# Access Compliance Report

## Public Rights-of-Way

### (Curb Ramps)

Intersection ID: 15833	Main Street: SOUTH_BV	Cross Street: CLANTON_RD	Location: SE
ADA ID: 67F483FAD14E	Ramp Type: Perp	Initial Pass/Fail: Fail	Overall Compliance: No
Severity Score: 8.75			
Codes/Mitigation Info/Possible Solution		Field Measurements/Component Compliance

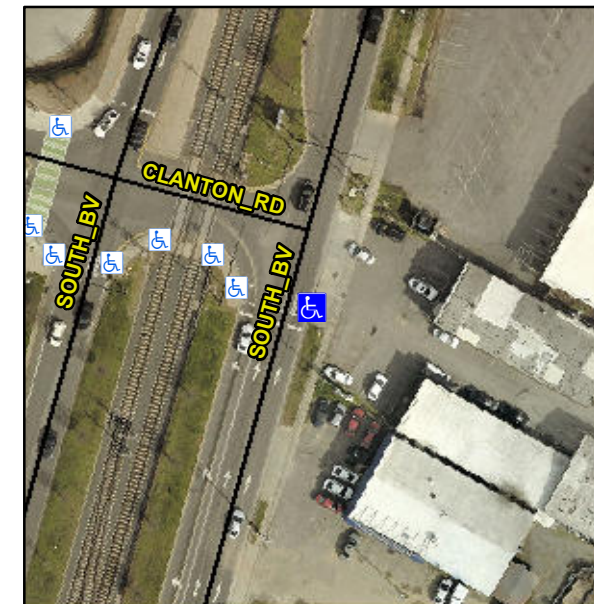
**Not Found, R304.5.1**

Compliance	Description	Data	Compliance	Description	Data
N/A	Ramp Length (in)	110.0	Yes	Ramp Slope (%)	5.4
No	Ramp Width (in)	47.0	Yes	Ramp XSlope (%)	0.8
N/A	Flare Type LT	N/A	N/A	Flare Type RT	N/A
N/A	Flare Slope LT (%)	N/A	N/A	Flare Slope RT (%)	N/A
N/A	Flare Traversable LT?	N/A	N/A	Flare Traversable RT?	N/A
N/A	Landing Length (in)	N/A	N/A	DWS Provided?	N/A
N/A	Landing Width (in)	N/A	N/A	DWS Contrast?	N/A
N/A	Landing Slope (%)	N/A	N/A	DWS Length (in)	N/A
N/A	Landing X Slope (%)	N/A	N/A	DWS Full Width?	N/A
N/A	Landing Curb? (Y/N)	N/A	N/A	DWS Offset (in)	N/A
N/A	Shared Landing?	N/A			
N/A	Gutter Ponding?	N/A	N/A	Gutter Slope (%)	N/A
N/A	Gutter Lip Ht (in)	N/A	N/A	Gutter X Slope (%)	N/A
N/A	Painted X Walk1?	Yes	N/A	Painted X Walk2?	N/A
	X Walk 1 Direction	To NW		X Walk 2 Direction	N/A
N/A	X Walk 1 Width (in)	112.0	N/A	X Walk 2 Width (in)	N/A
	X Walk 1 Slope (%)	0.4		X Walk 2 Slope (%)	N/A
	X Walk 1 X Slope (%)	0.3		X Walk 2 X Slope (%)	N/A

**Remove & Replace Entire Ramp.**
